ILLINOIS POWER COMPANY

CLINTON POWER STATION, R.R. #3, BOX 228, CLINTON, IL 61727

Illinois Power Company is in the process of reviewing the Remote Shutdown Panel (RSP) based on items raised in the Control Room Audit/Review from human factors engineering. I would like to address specifically two items raised in the review since these require major modifications to the panel.

FIGURE 1. RSP (RESENT CONFIGURATION)

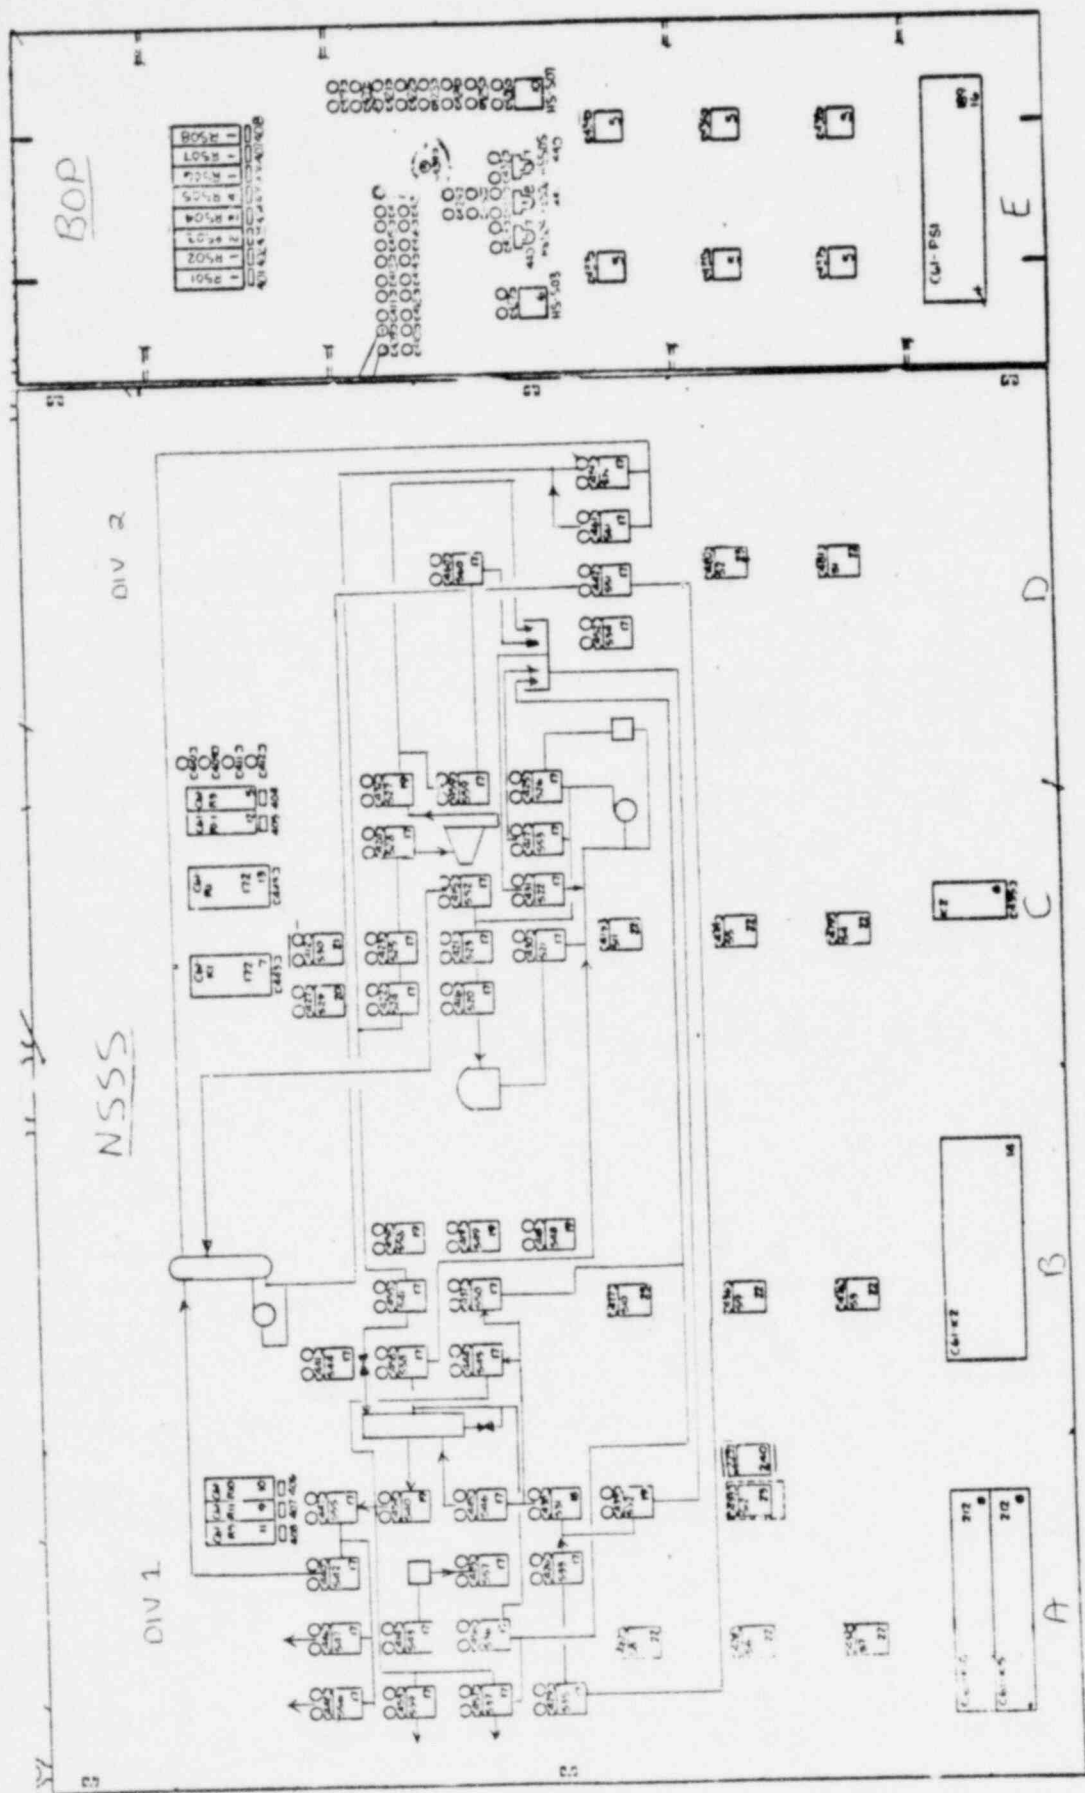
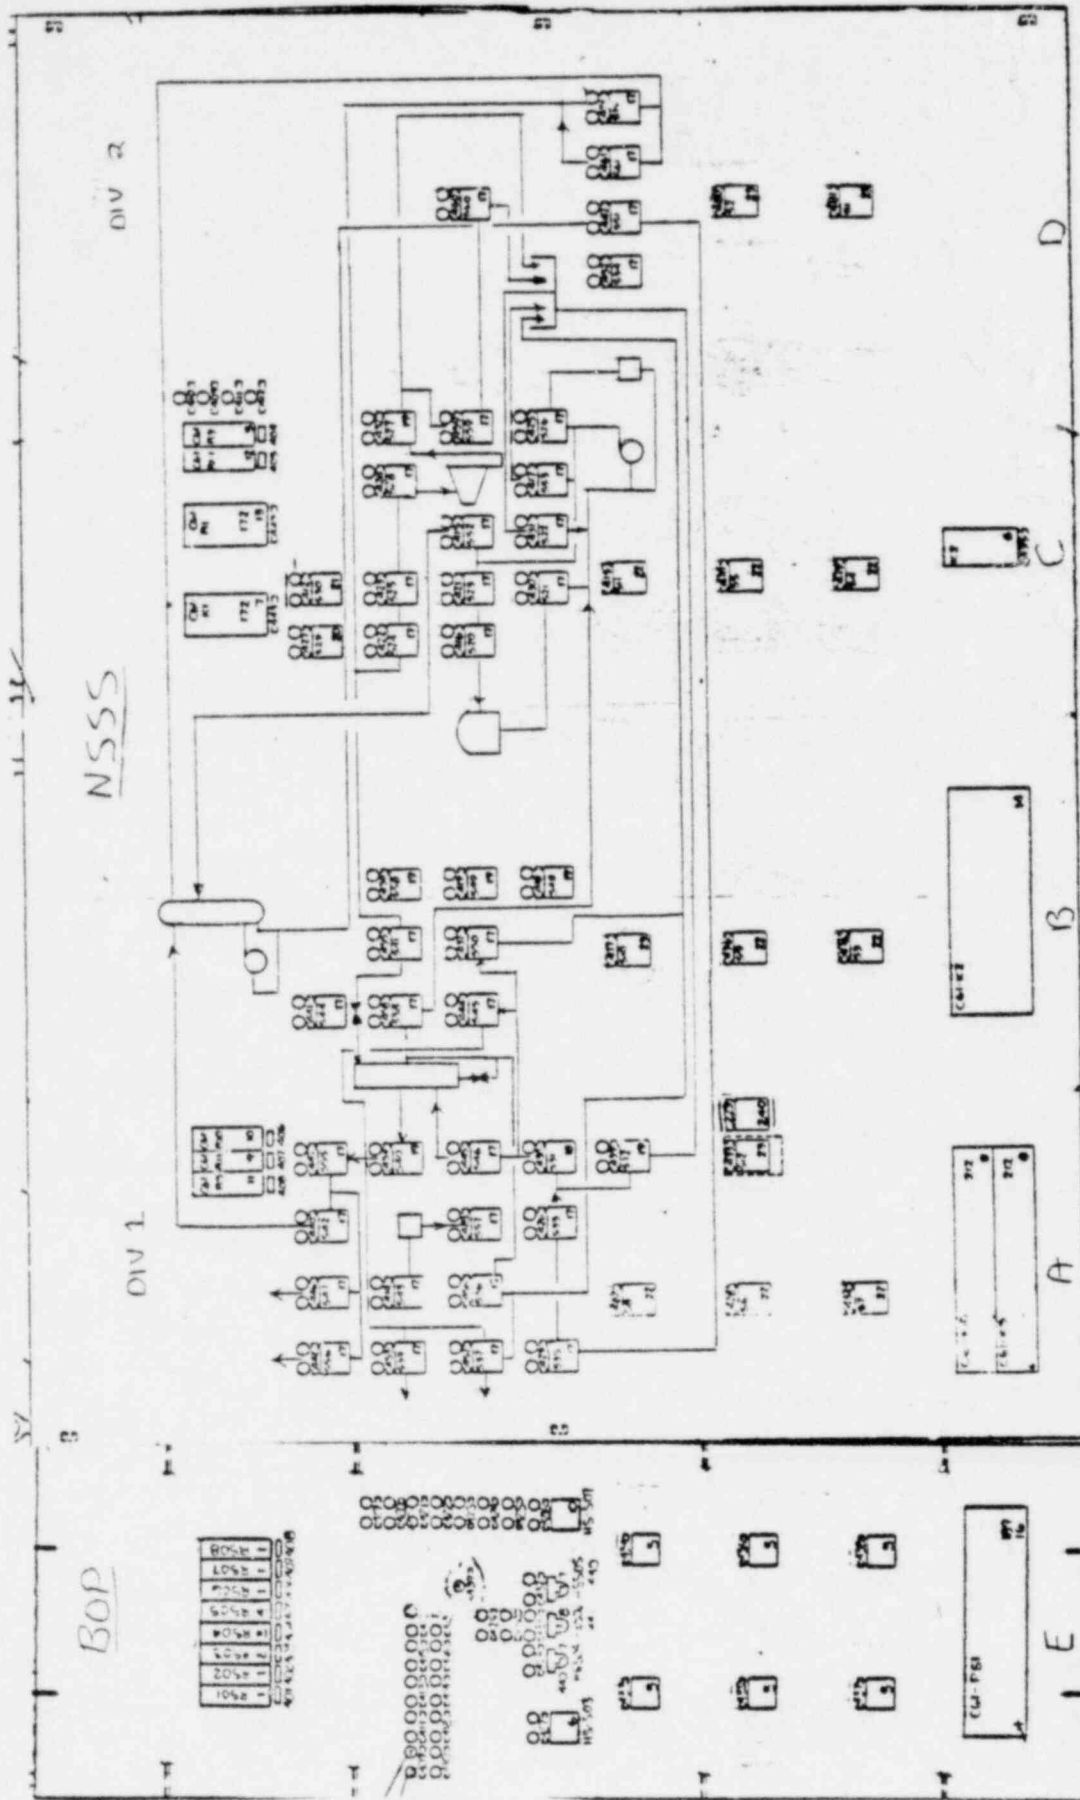
The first is in response to item C-1.1 of the audit which deals with the spacing between the RSP and the adjacent electrical panel. Figure 1 shows the panel as it currently exists, consisting in order of Bays A, B, C, D and E. Bays A, B, C, and D constitute one assembly as does Bay E. IPC plans to rotate each assembly 180 degrees with the final arrangement of the panel being as shown in Figure 2. This rotation will increase the operating space of the RSP from 32 inches to approximately 48 inches which is the maximum attainable and we feel is adequate for safe operation of the panel.

The second concern which I would like to address, is in regard to item C-9.3 of the audit which states that the meters in the BOP section of the RSP cannot be read from the location of the associated NSSS division 1 controls in the middle and left sections of the panel. It is clear from looking at Figure 2 that the rotation of the panels significantly reduces the distance between the meters and the controls. In addition to this, IPC is installing four division 2 meters in the NSSS division 2 section of the RSP. These meters are redundant to the division 1 meters indicating; Reactor Water Level and Pressure, and Suppression Pool Temperature and Level. These meters will be installed so that the information is conveniently located for the operator when operating the RSP.
